PROJECT
OFFICE ALTERATIONS
FOR
THE LANTIS CORPORATION

LOCATION
10 STATE STREET
MOONACHIE NJ 07074
BLOCK 31 - LOTS 10, 12

DRAWING
GENERAL CONSTRUCTION
1ST & 2ND FLOOR OFFICES

A-1

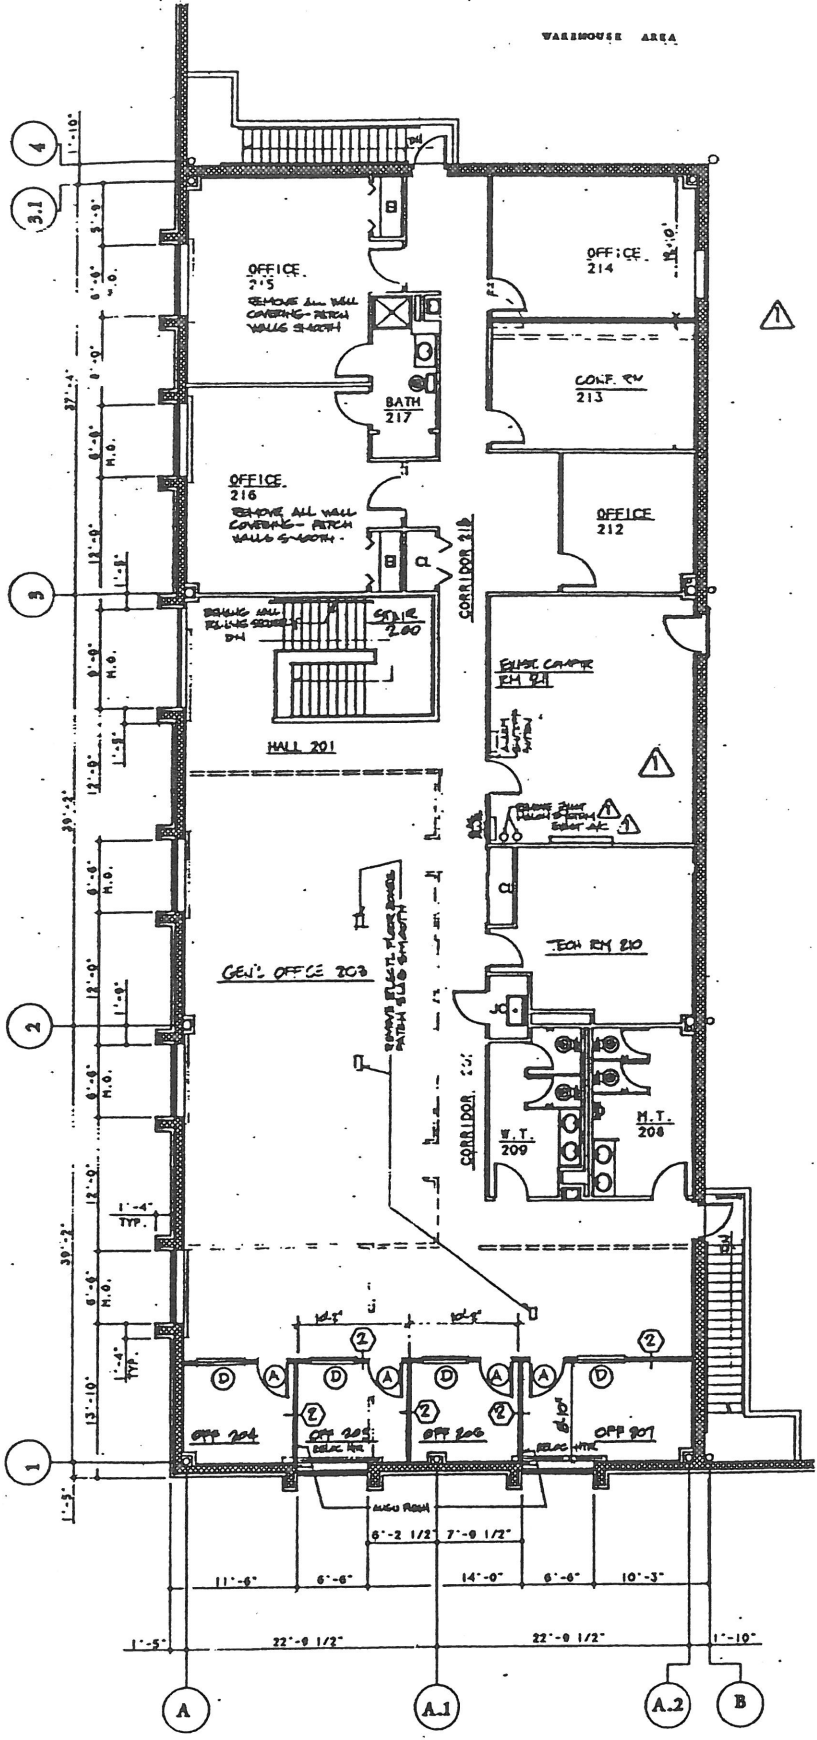
CHG EXISTING PIPING IN WALL. BRU
EDWARDS PIPING TO SUFFICIENT DEPTH
NEW BAR BANK.
PROVIDE 1" DIA BRU SYSTEM
AL FOR PUMPING RM 102 -
SET COMPRESSOR ON ROOF

1/2" DIA BRU UNDER
OFFICE 113
1/2" DIA BRU UNDER
OFFICE 111 & LUNCH
AREA (1) OFFICE 111
1/2" DIA BRU UNDER
OFFICE 113

PROVIDE CLOSED
DOORS FOR FULL STAIR
CORR. 106

BASE CAB. OFFICE
104
EXISTING CAB. FROM
STAIR TO ADMINISTRATIVE
WALL CH. LUNCH RM 102
ELECTRICAL

GET TO CLASH
TEL. BOX
CHANG TEL. SERVICE BOX
WOOD SHELVES

ADDED PARTITION BETWEEN 104/102, 104/105,
104/105 & 213/214. CHANGED OFFICE 214
TO 213 HALL & AC IN 214. 5/17/93
